RE: PROJECT - NW CORNOR OF COORS BLVD & ST. JOSEPH DR. (COORS PAVILION) – ALBUQUERQUE, NM. 87120.

PROJECT NUMBER: 10000032, APPLICATION NUMBER: 17-70001

ADMINISTRATIVE AMENDMENT TO SITE DEVELOPMENT PLAN FOR BUILDING PERMIT TO ADD AN OUTDOOR PATIO

| SHEET NO. | AS101 |

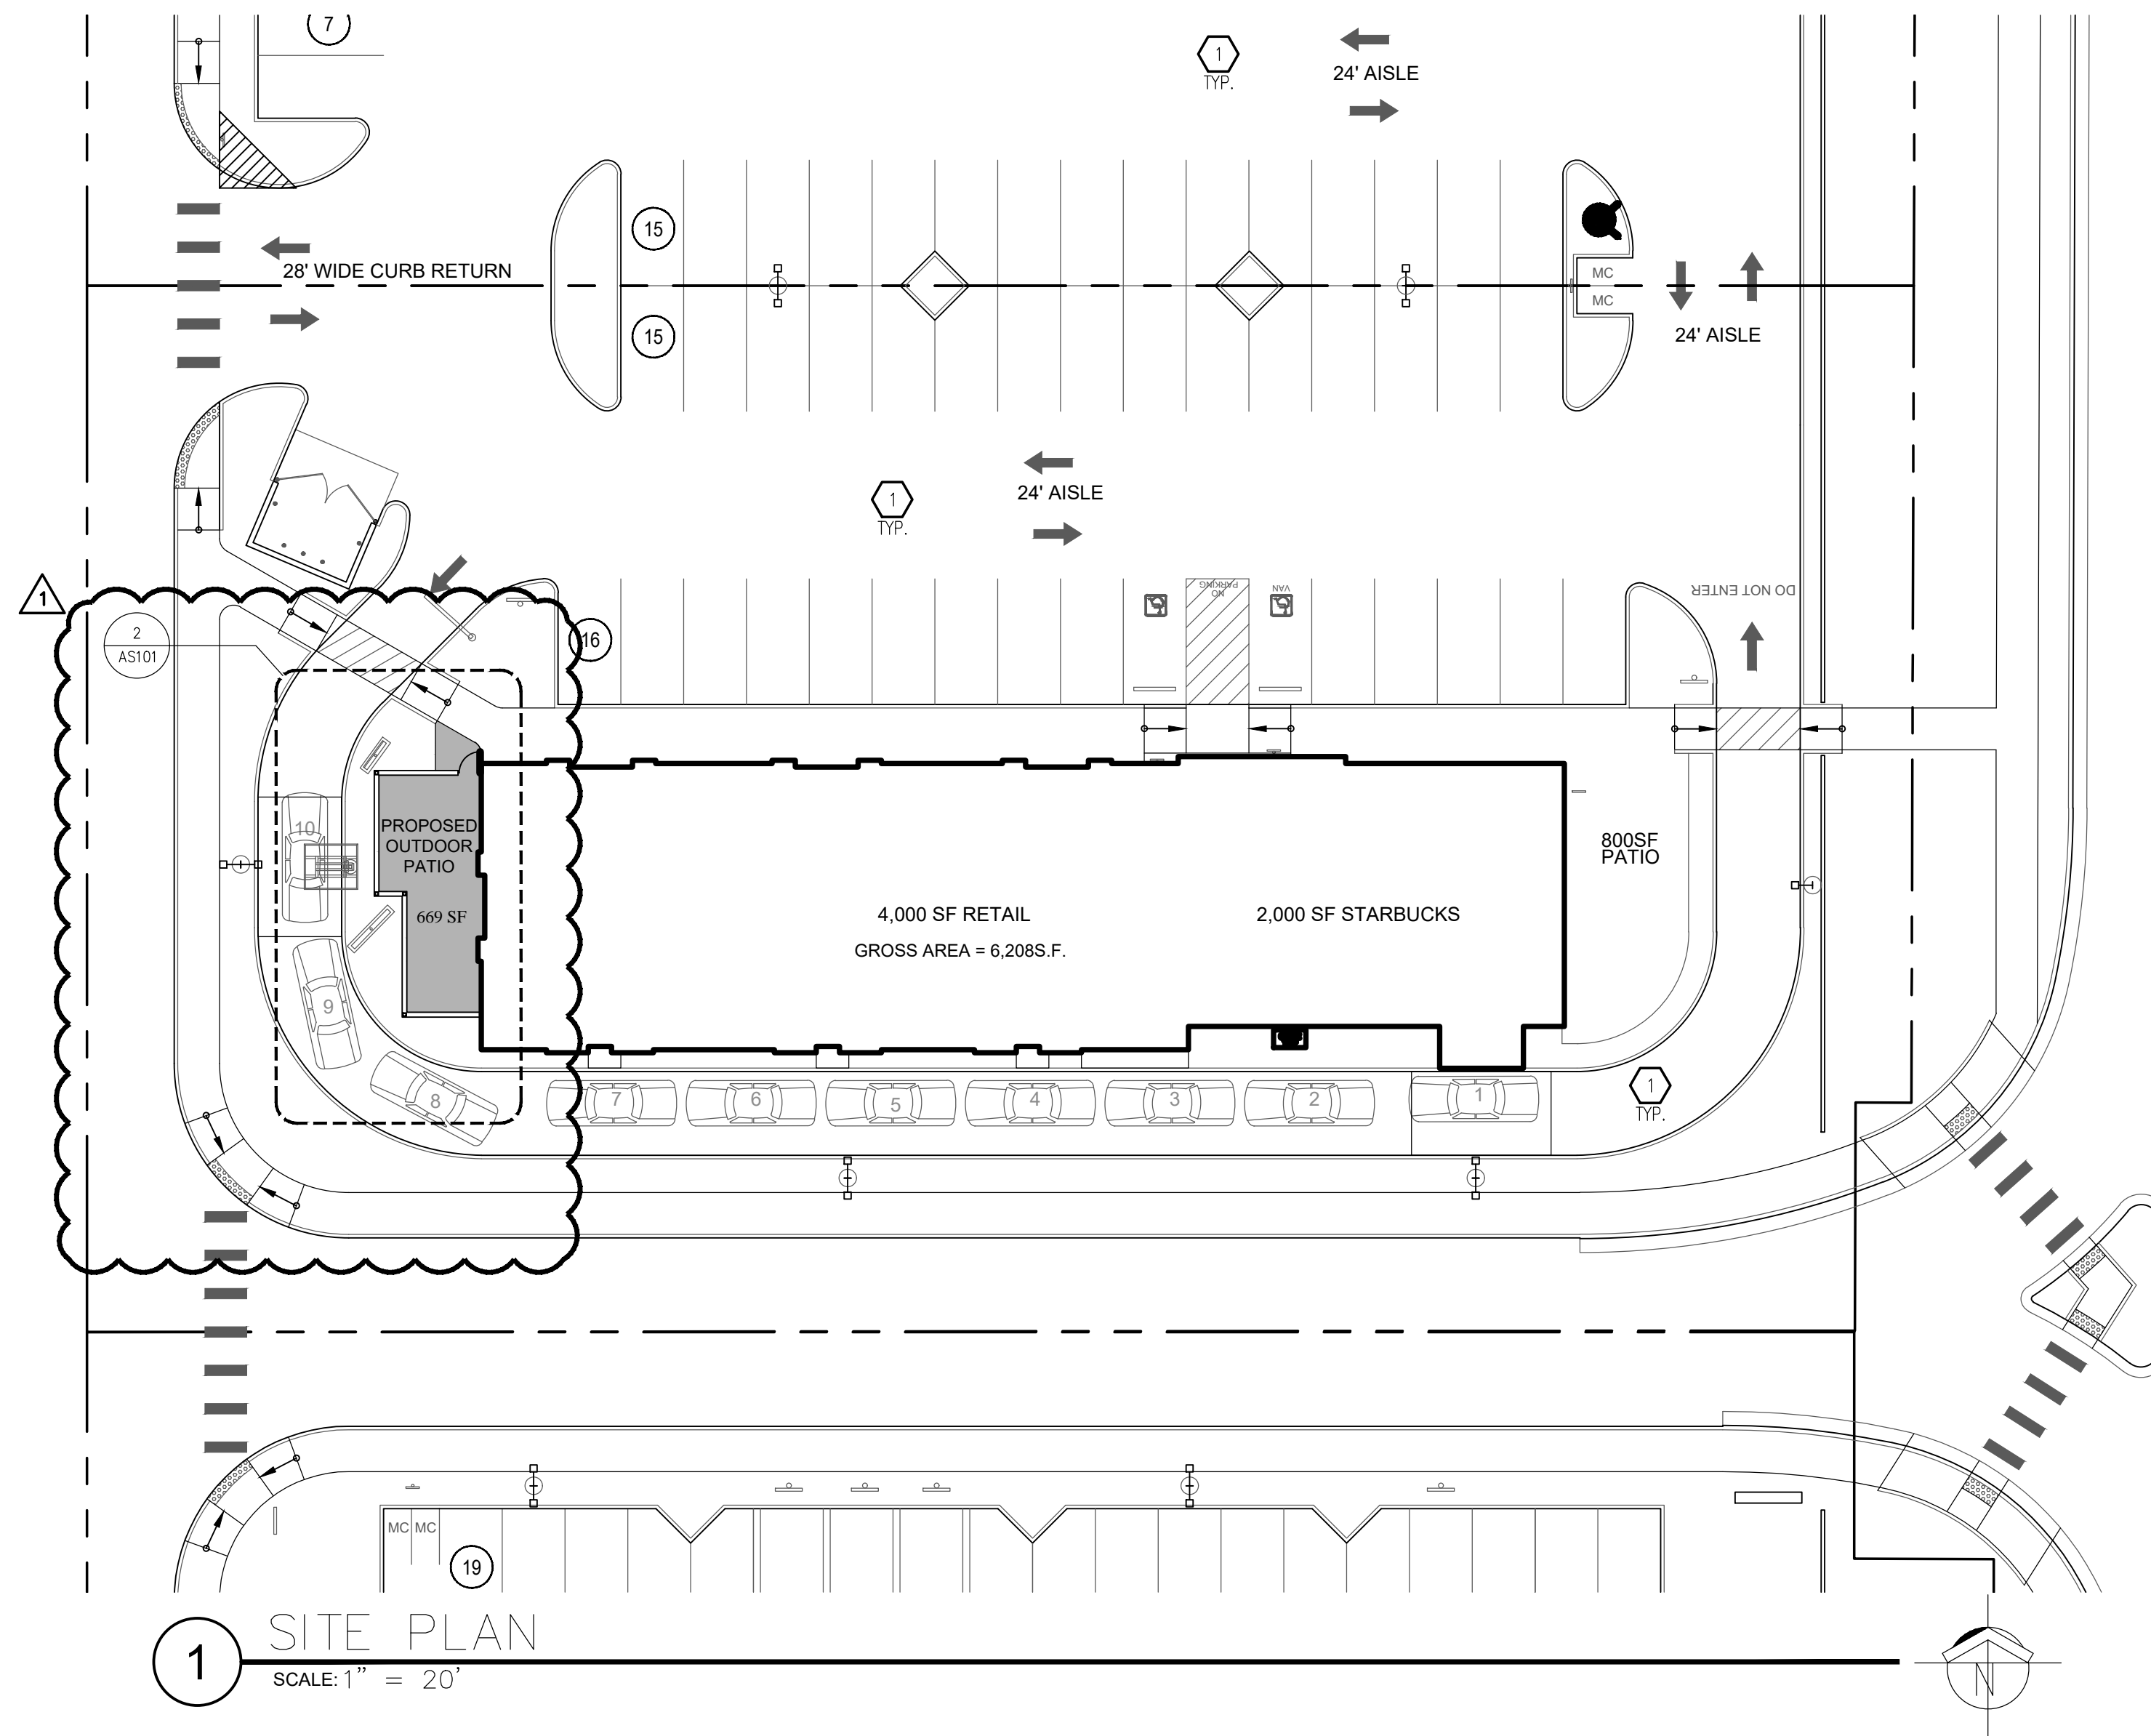
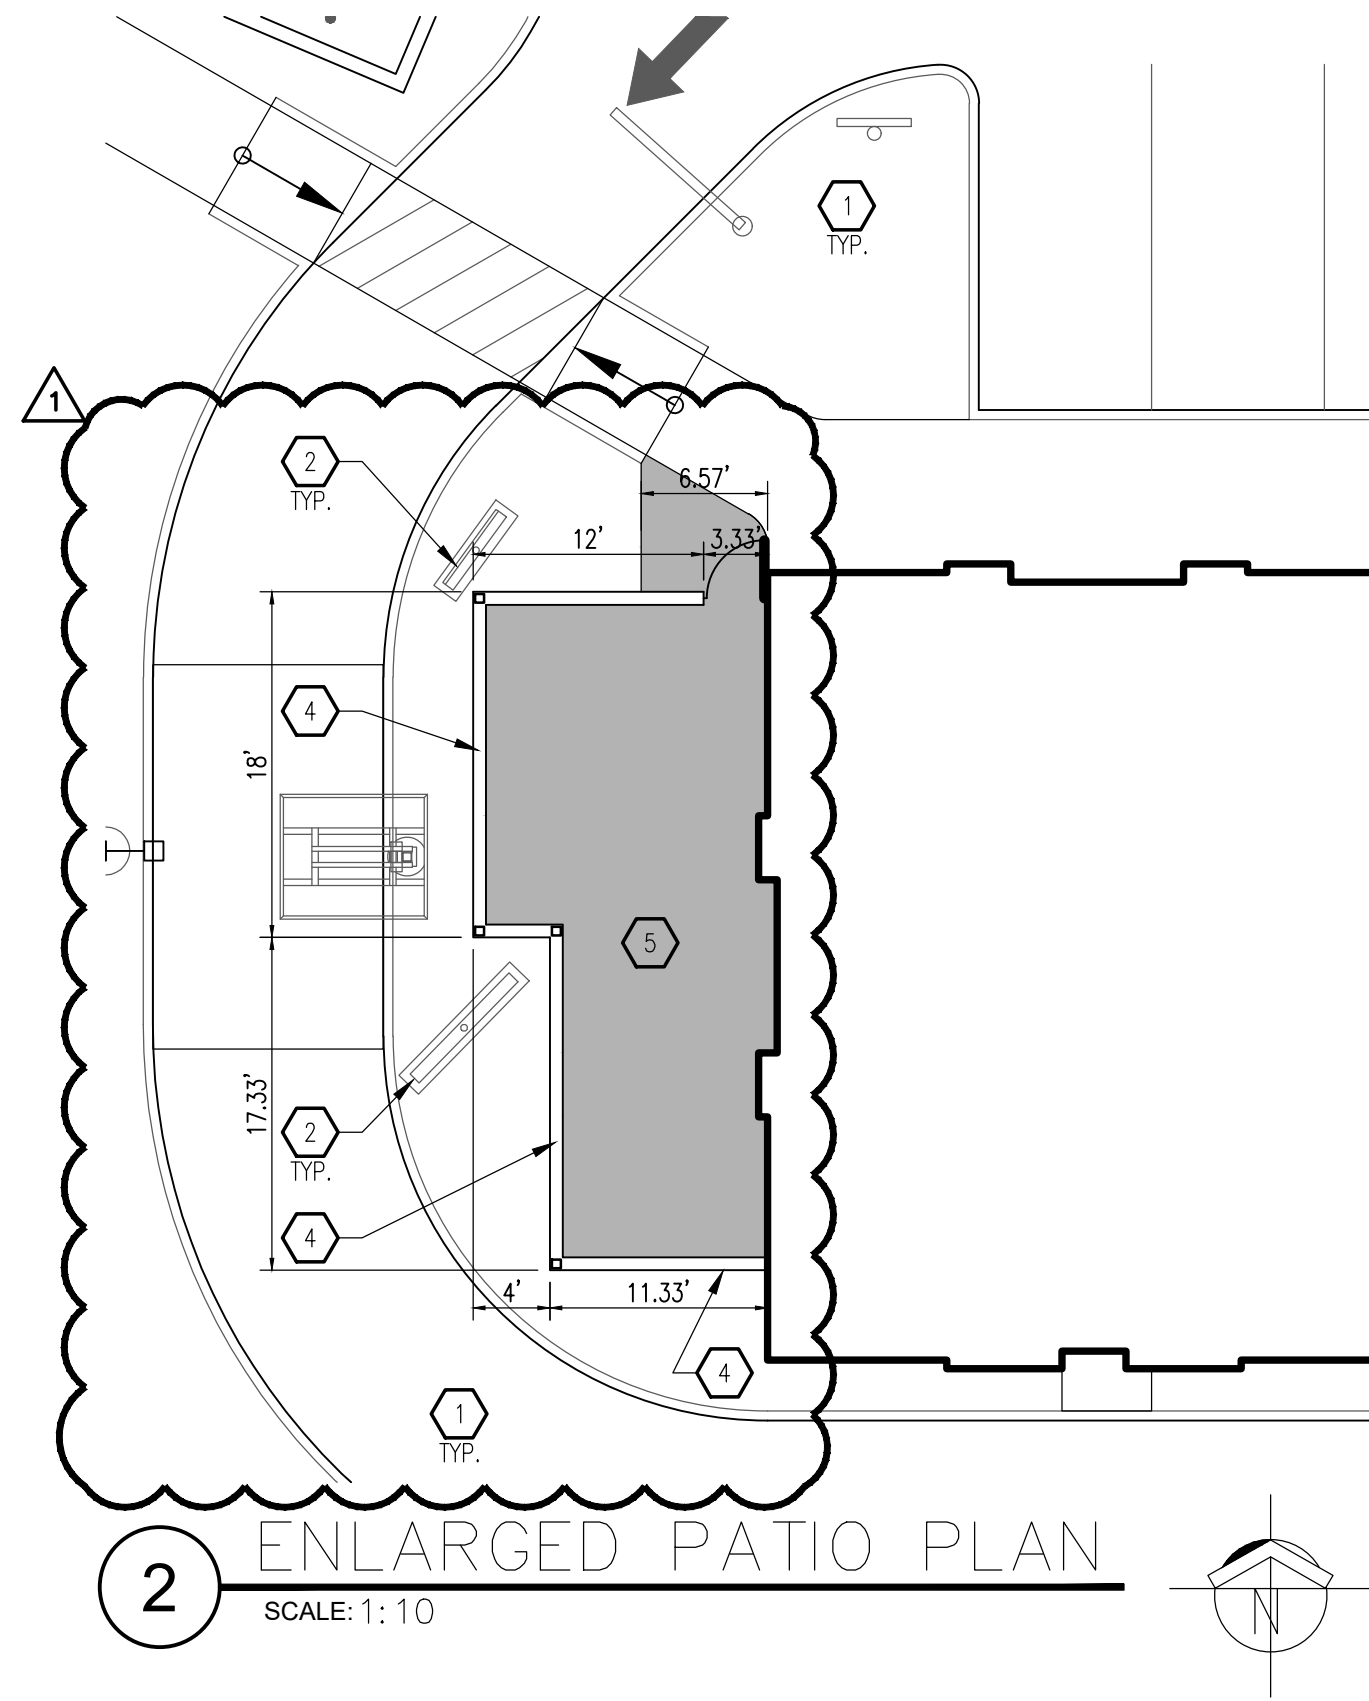
1. Per the design standards outdoor patio space is required for a restaurant (See DS01 “Pedestrian Connection & Amenities”). A 669sf patio with as masonry screening wall to has been added to the Site Plan (SPBP-1).

| SHEET TITLE EXTERIOR ELEVATIONS | |

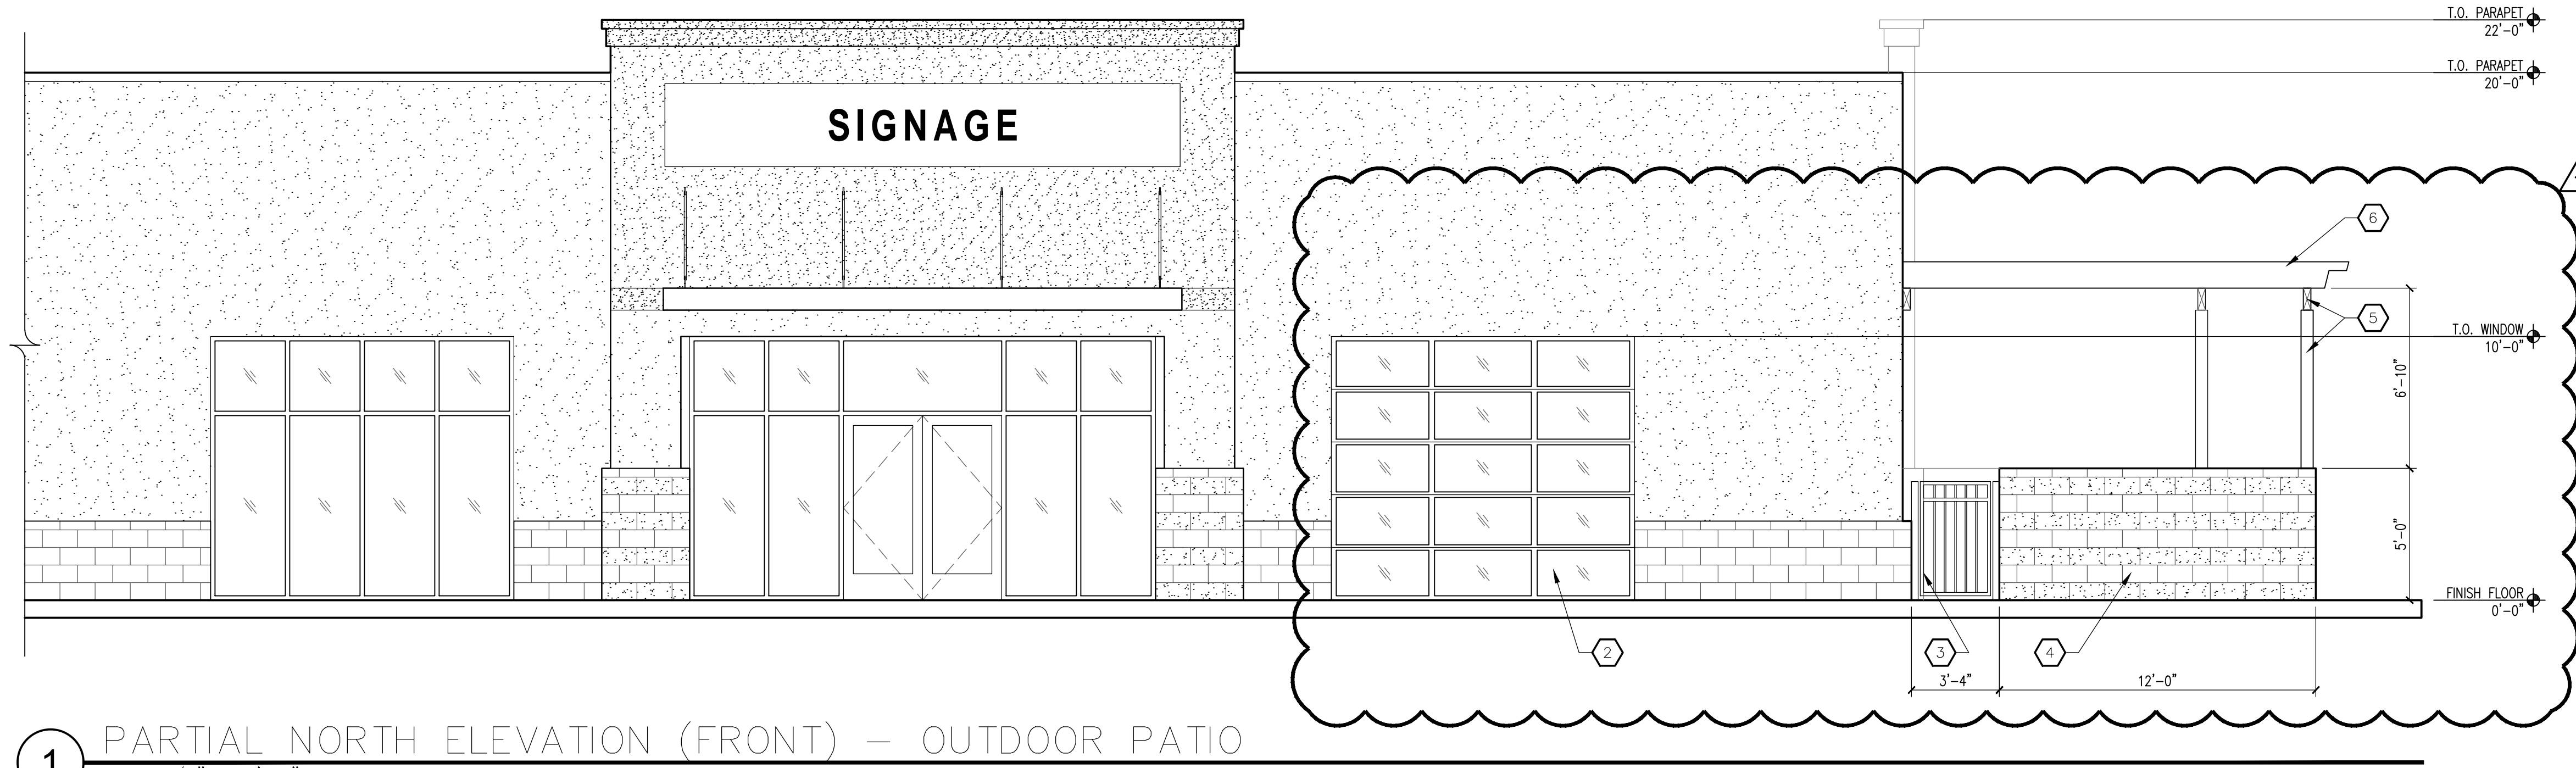
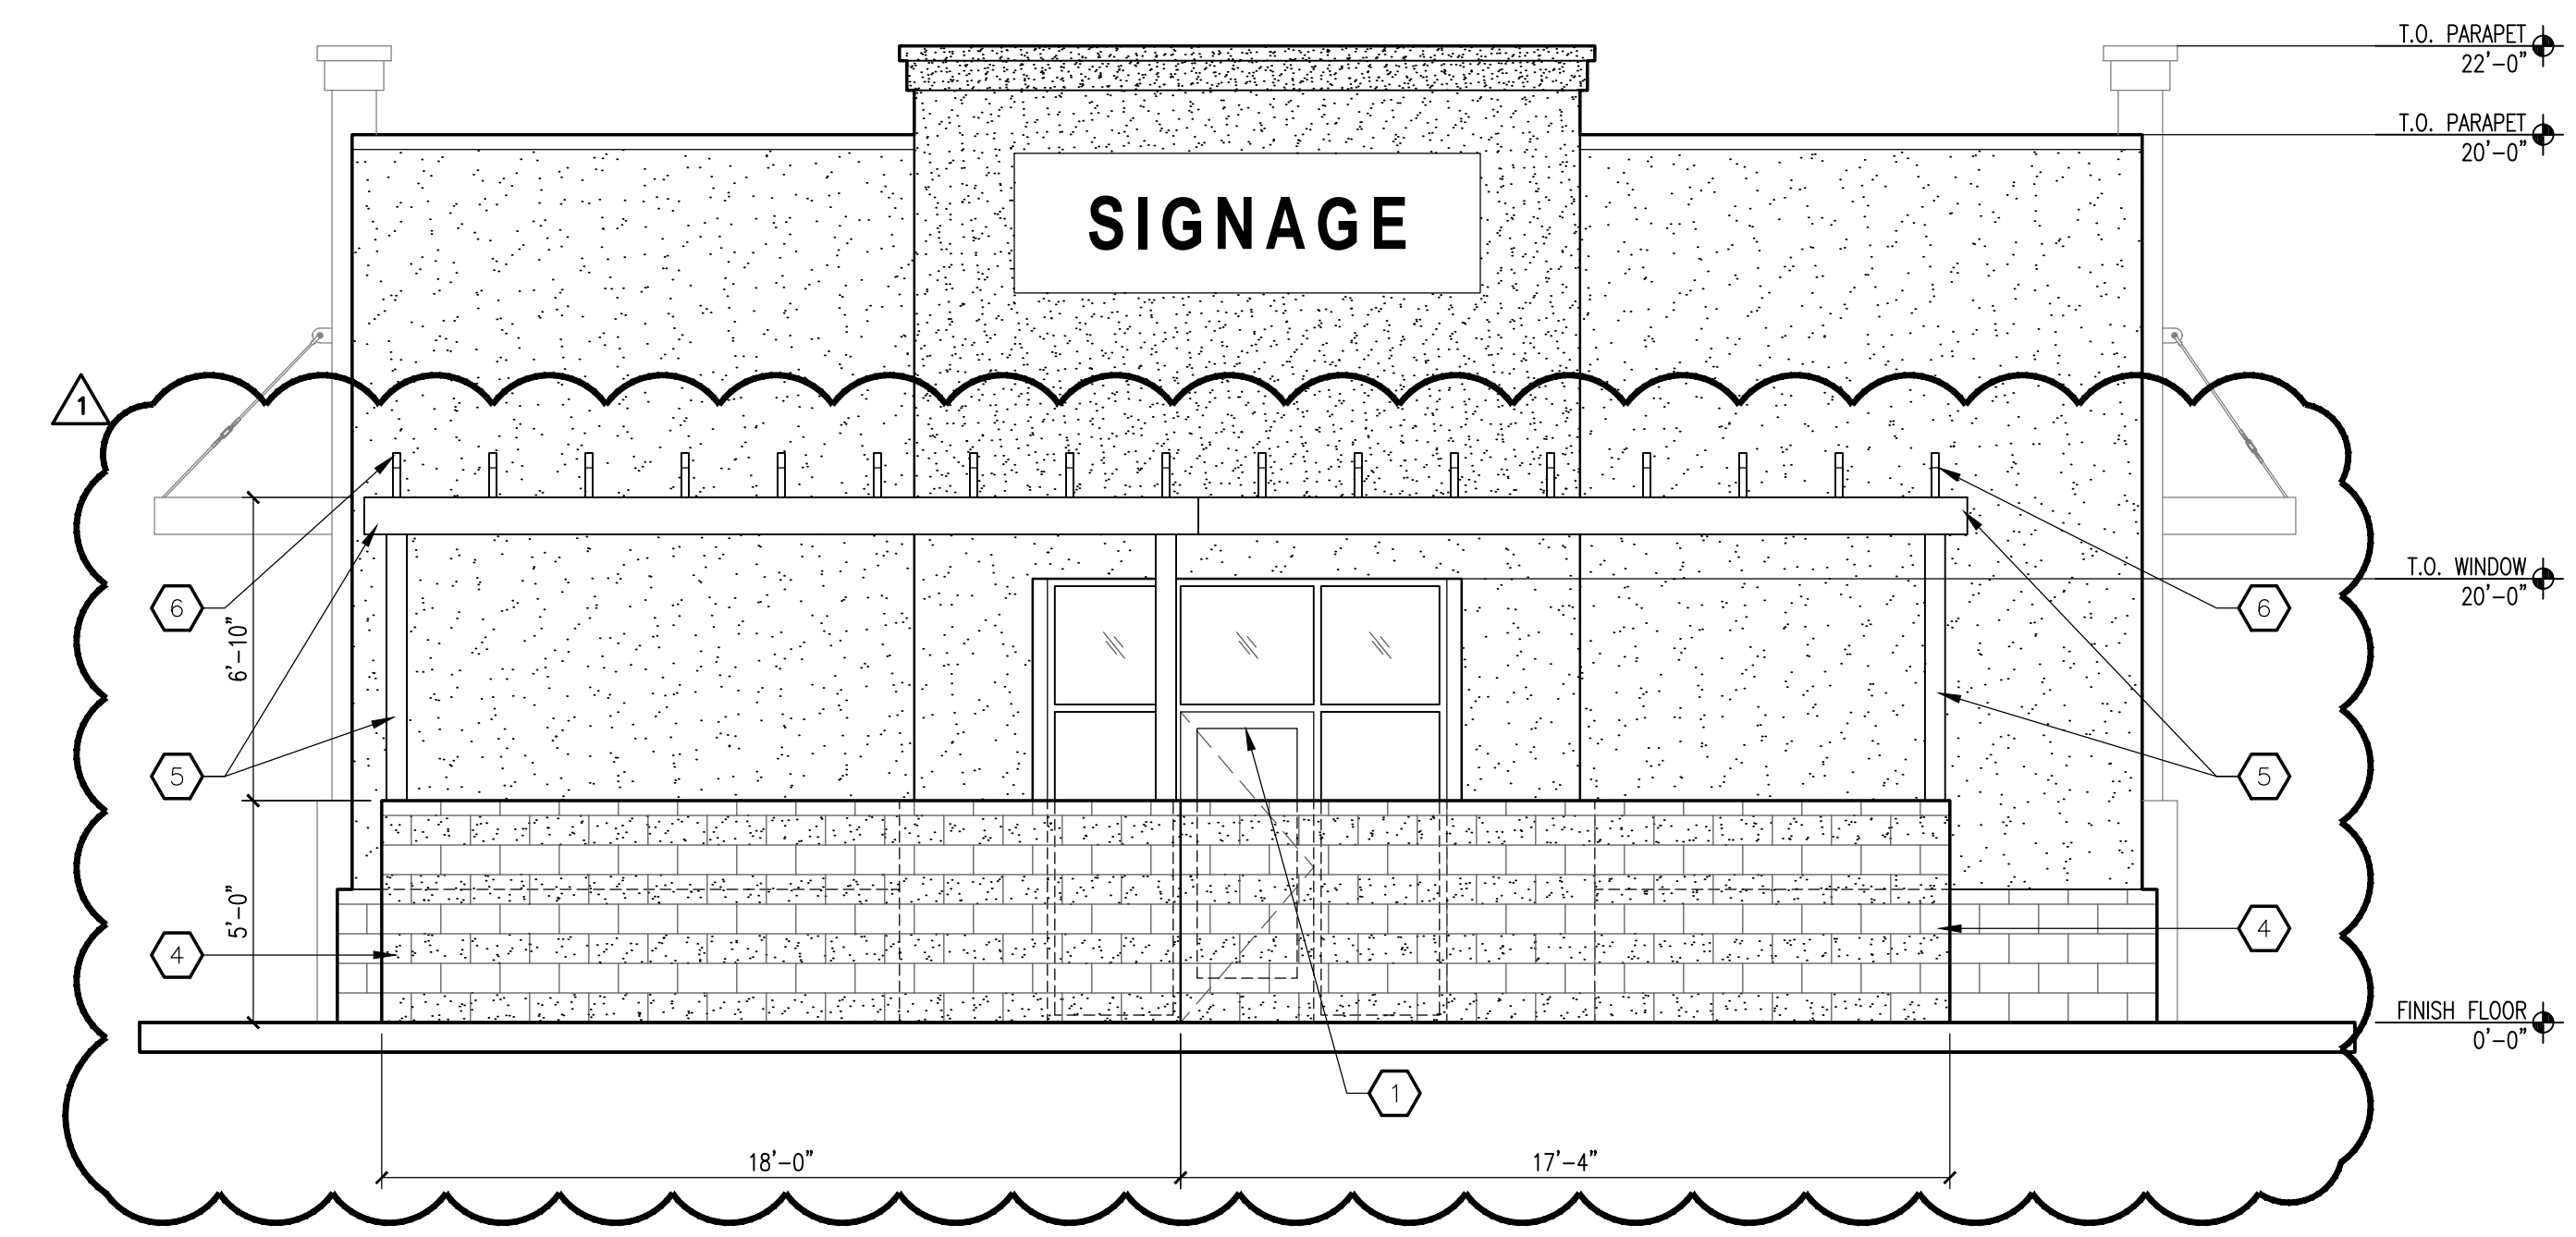
1. Per the design standards outdoor seating is required to have areas of shade (See DS01 “Pedestrian Connection & Amenities. A pergola has been proposed to come off the west side of the building.
2. A garage glass roll up door will take the place of the existing storefront unit. The square footage will not change for the opening.
3. The 5’ tall CMU wall has been added to cover the required outdoor patio.
